# PERMIT

## SEWAGE DISPOSAL SYSTEM

Re: Shallow Pressure Dosing  
System  
Lot 10, Middle Trails  
Howard County

SHALLOW PRESSURE DOSING SYSTEM  
LOT 10  
MIDDLE TRAILS  
MT. AIRY MARYLAND

**COMPARTMENTED 1500 GAL. SEPTIC TANK (TYPICAL)**  
SCALE: 3/4" = 1'-0"

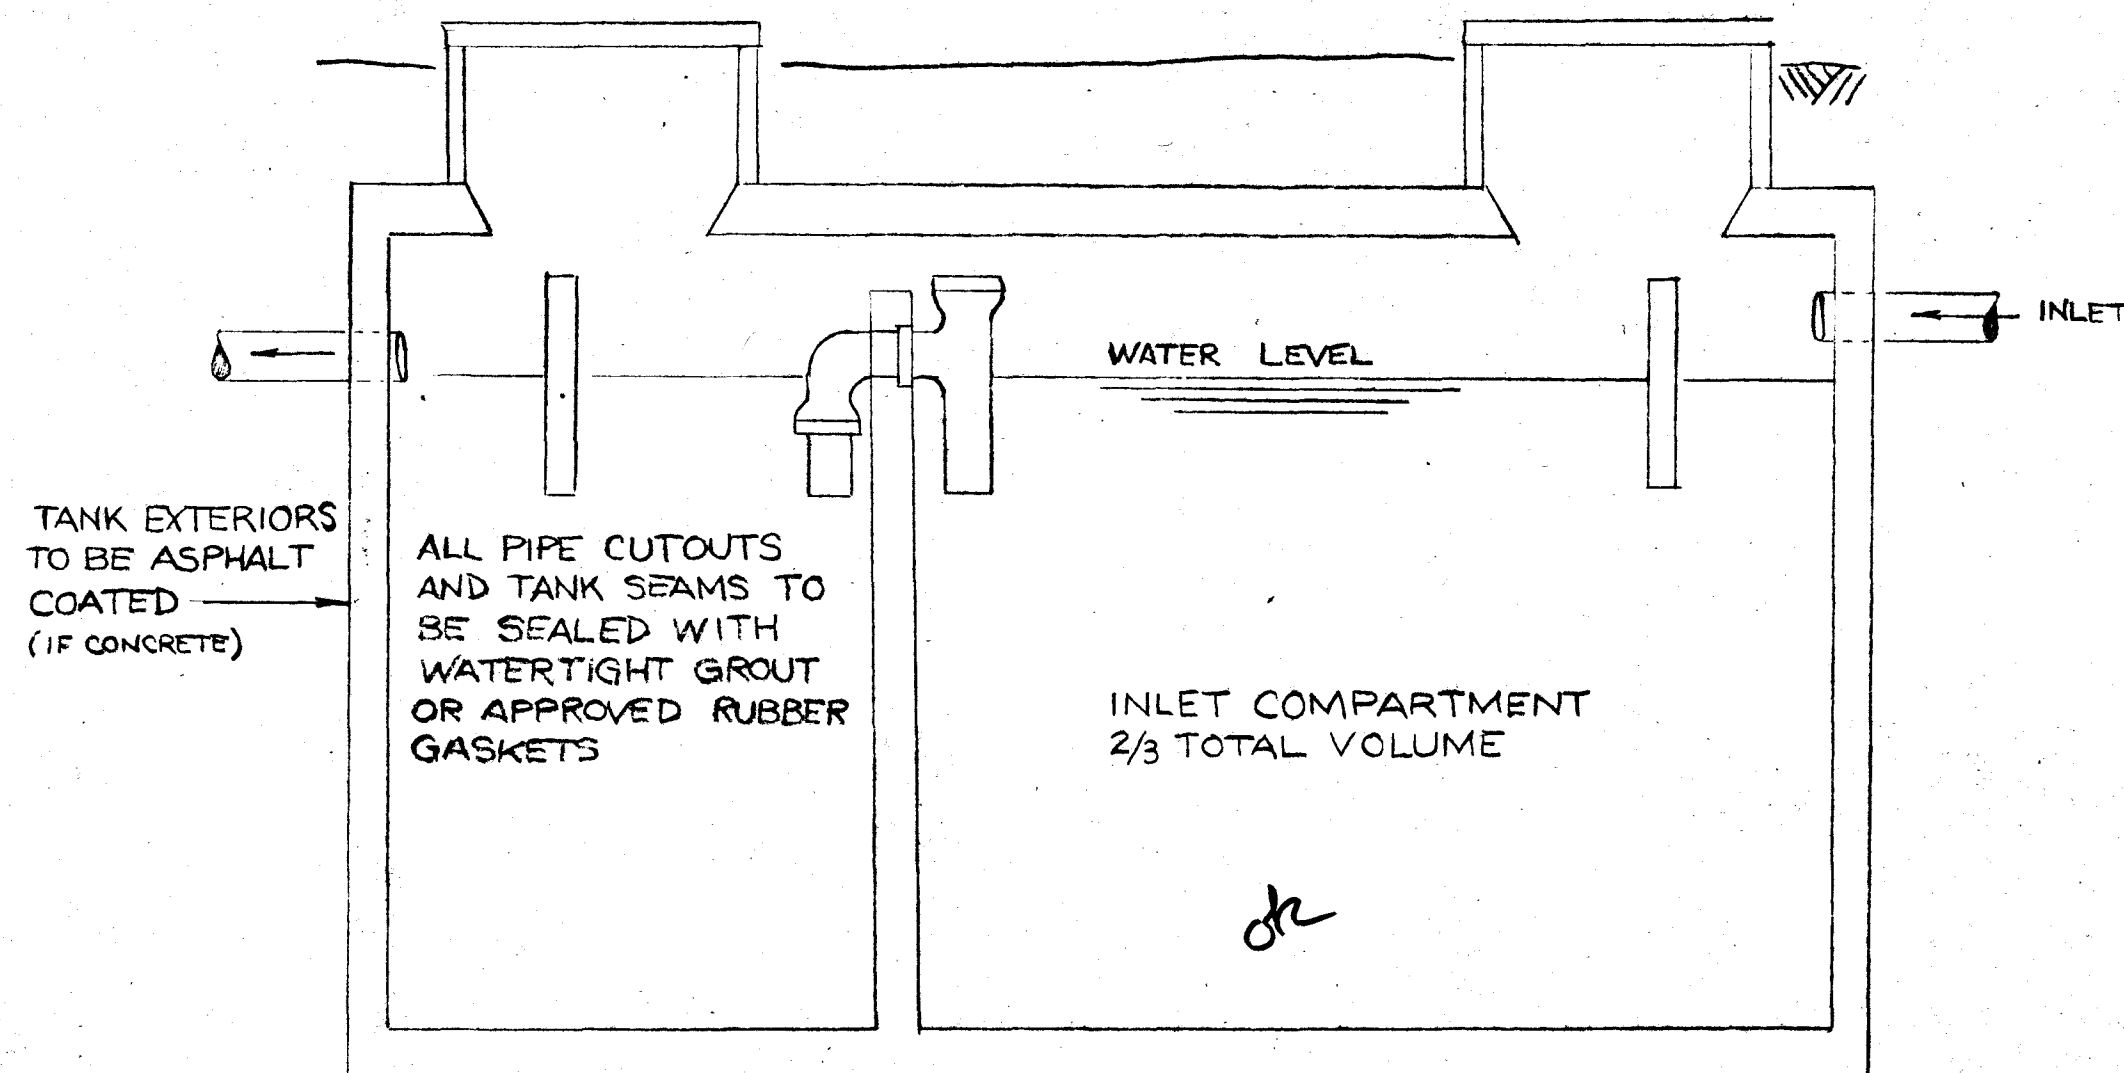
1. An access opening has been shown for the "T" baffle.
2. Tank dimensions. Dimensions and construction details are not normally shown on a "typical" drawing.
3. Same as #2 above.
4. Invert elevations have been shown.
5. Baffles have been extended.

**LATERAL END TURNUP DETAIL**  
NOT TO SCALE

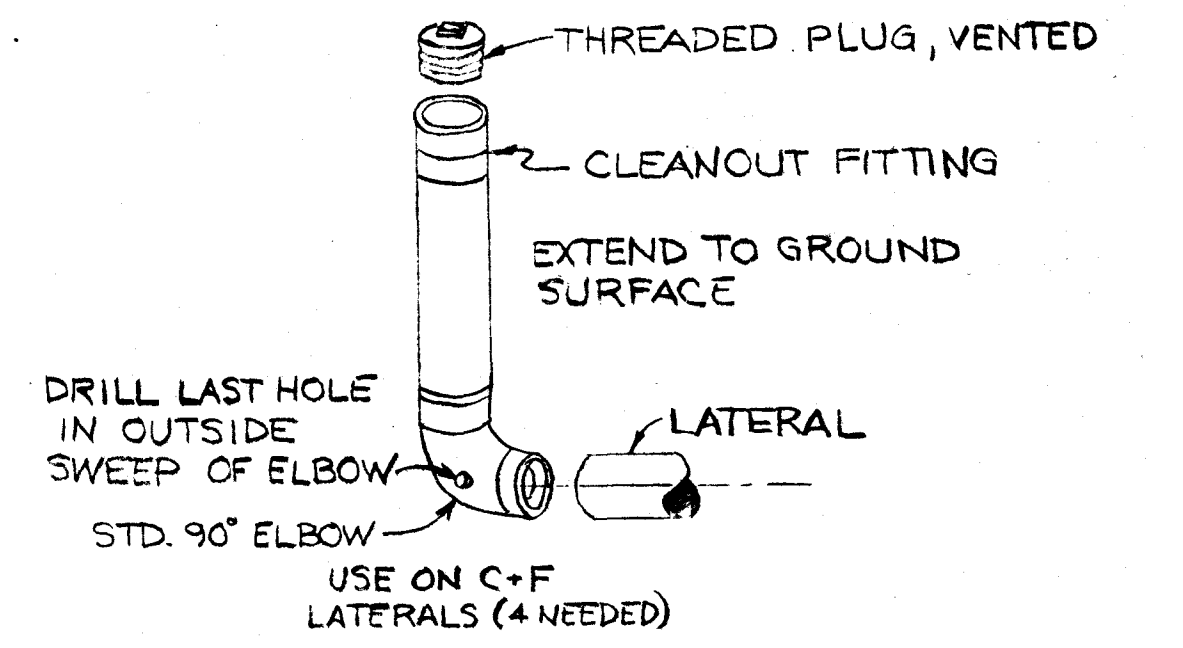
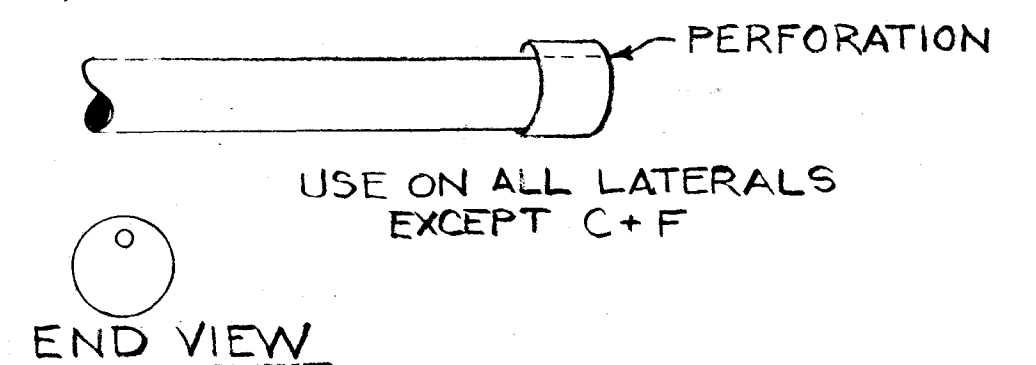
6. See lateral end turn up detail.

At the termination point of each lateral, the last perforation is to be placed in the turn-up elbow or end cap as shown on the drawing.

**DISPOSAL FIELD LAYOUT**  
SCALE: 1" = 10'

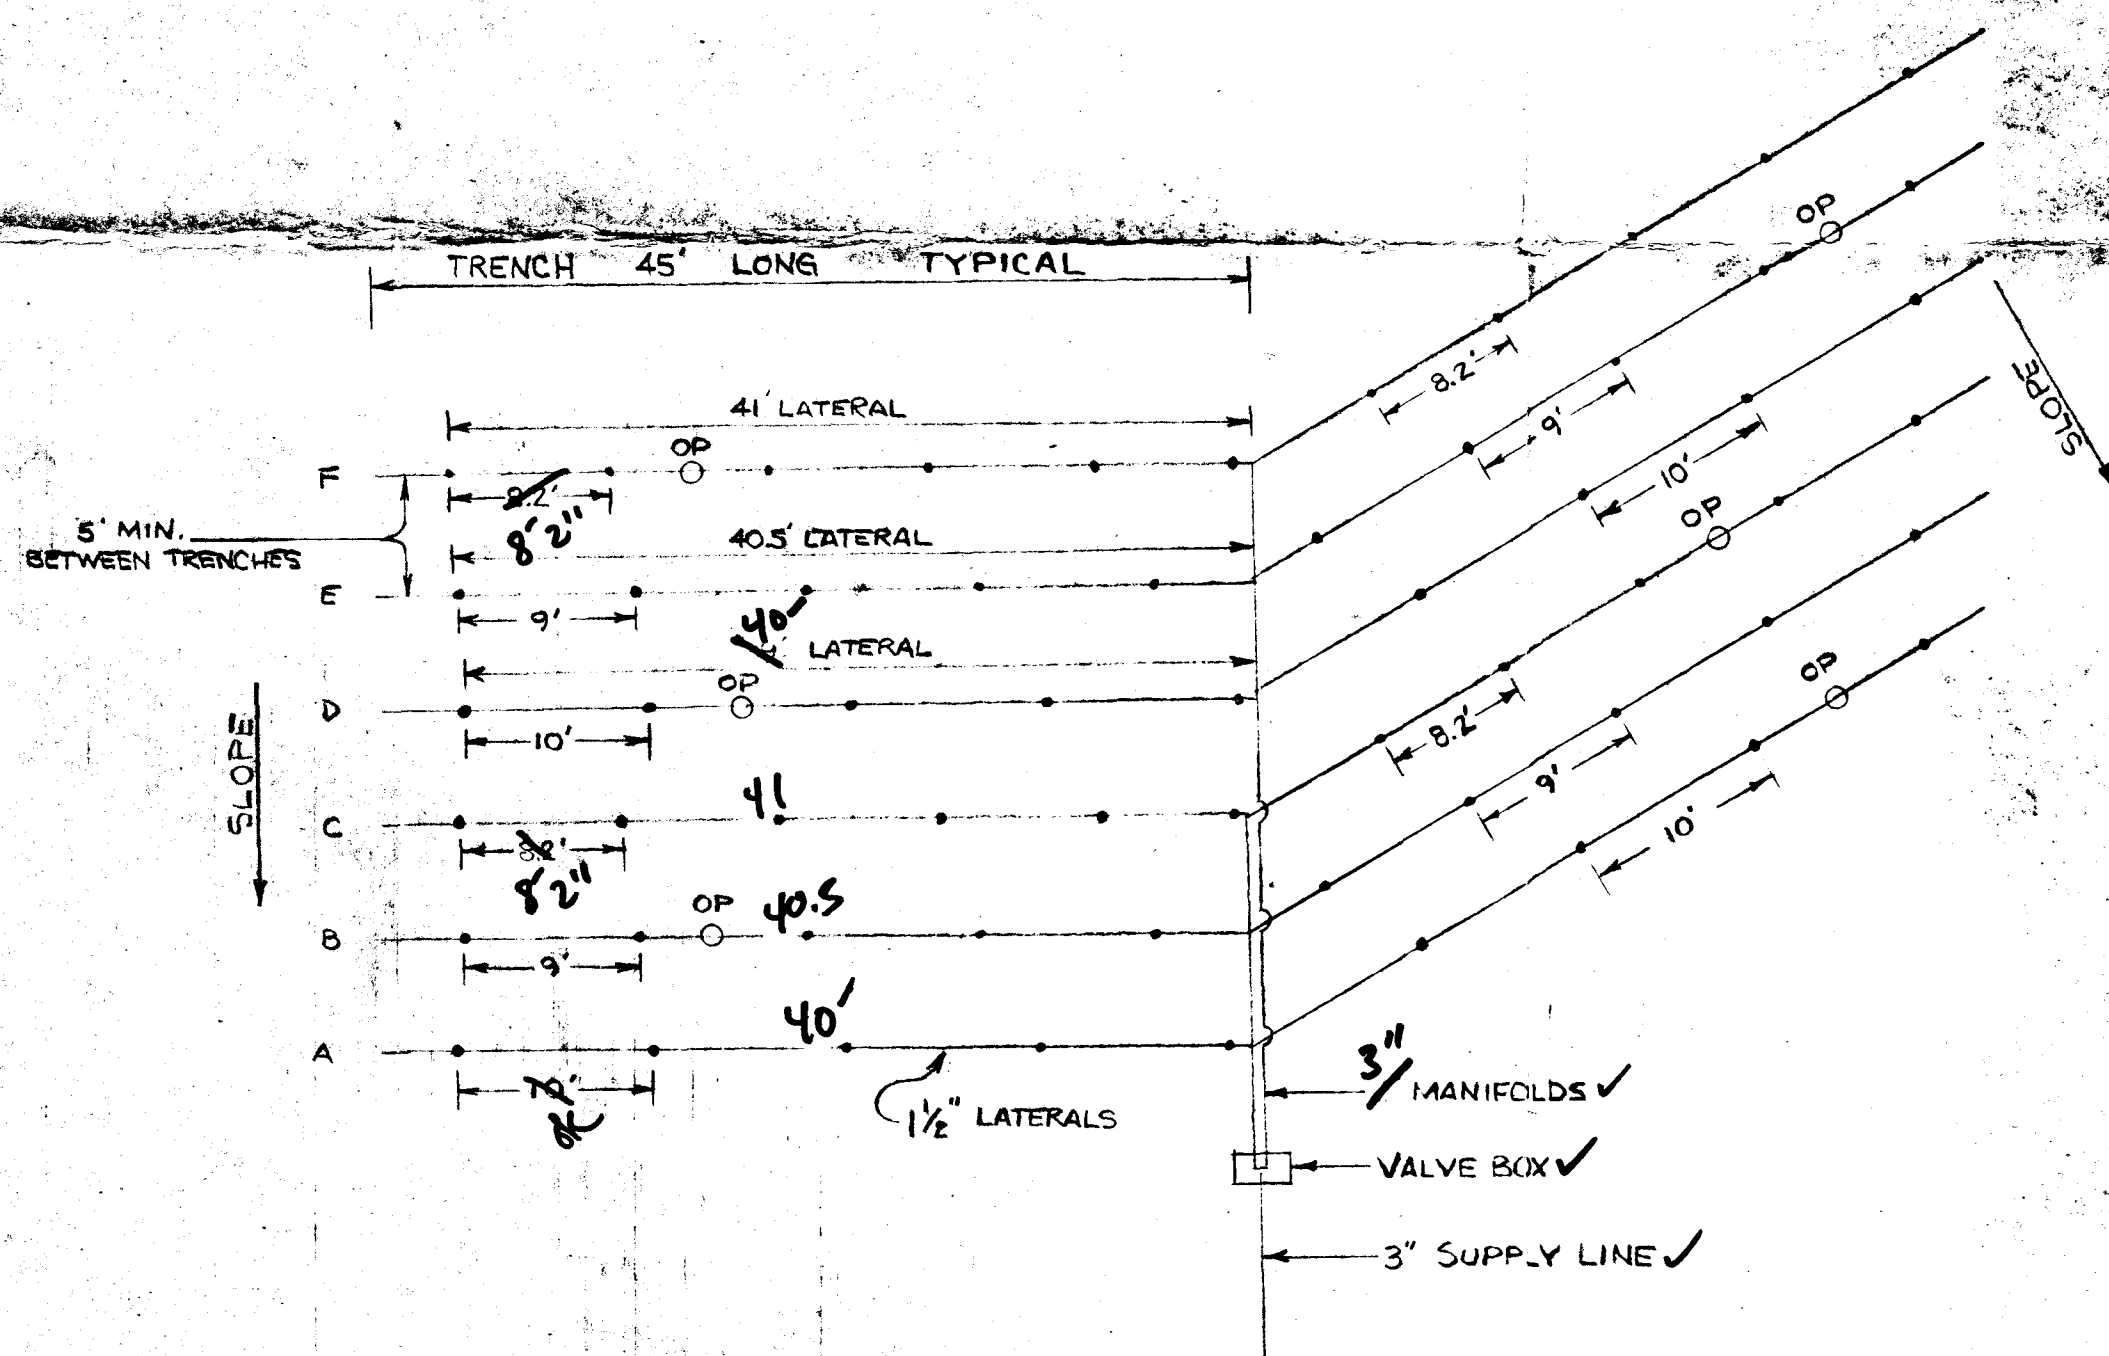
2. Please look at the drawing. The trench length and lateral lengths are clearly shown. This information has been summarized for each trench and each lateral in the included table.

3. Lateral hole locations and spacings are clearly shown on the drawing as submitted and again in the table.

4. Spacing between trenches is clearly indicated as 5' minimum.

**HYDRAULIC PROFILE**  
NOT TO SCALE

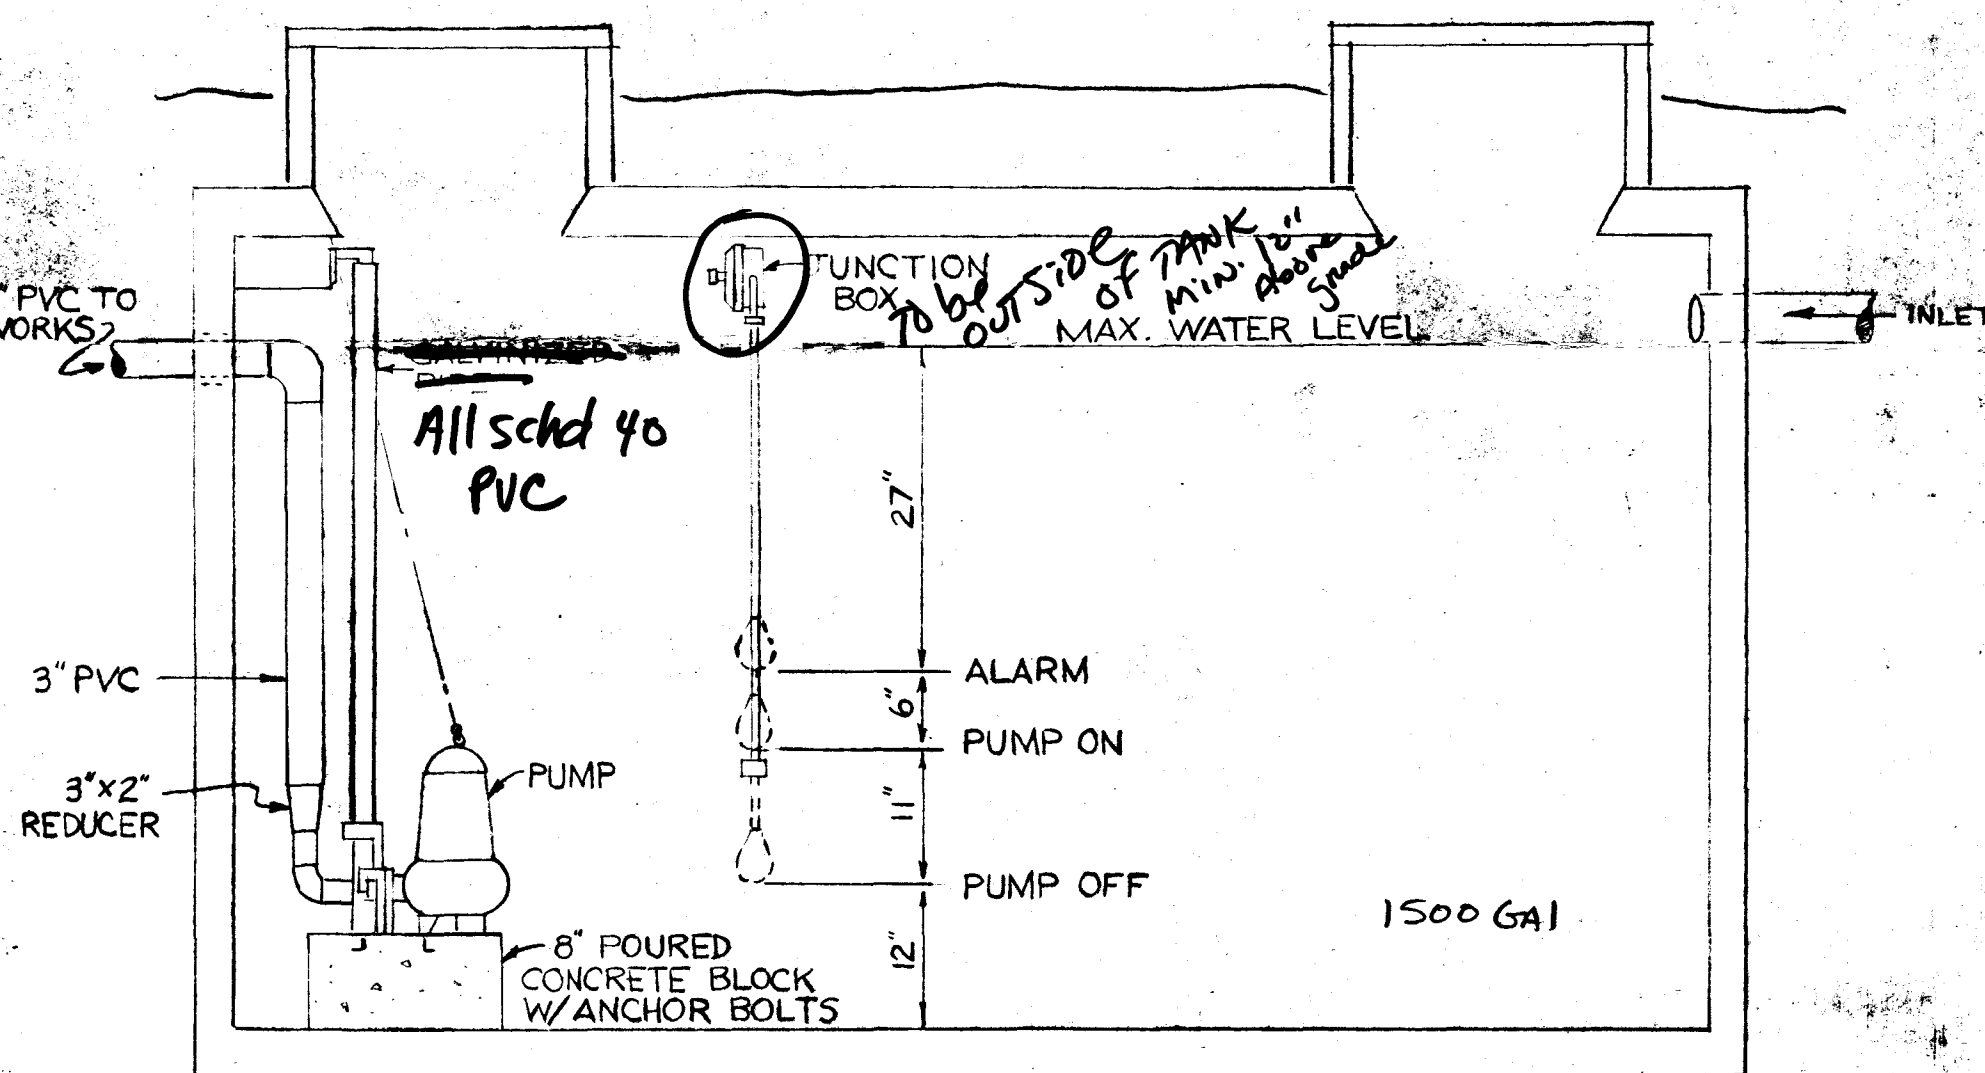
What "major turning points" are you referring to? The supply line is one straight line with elevations at both ends shown and an elevation difference of 16'.

The hydraulic profile as submitted also clearly indicates elevations of the top and bottom laterals and the valve box. As per your request we have transferred elevations from the profile to laterals A and F.

**LATERAL CONNECTING DETAIL (TYPICAL)**

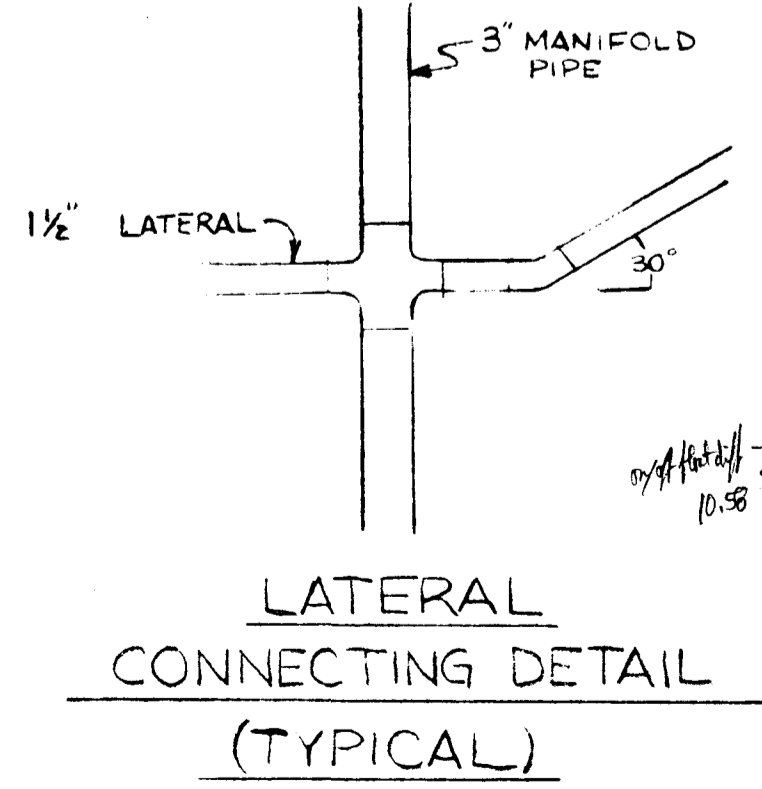
Site check OK - well is located 105' from beginning area to be used by LPD system, but septic tank and pump chamber will only be approx 75' from it, though down killif well is 160' down slope of neighbor's existing SPST strands. 8/19/91
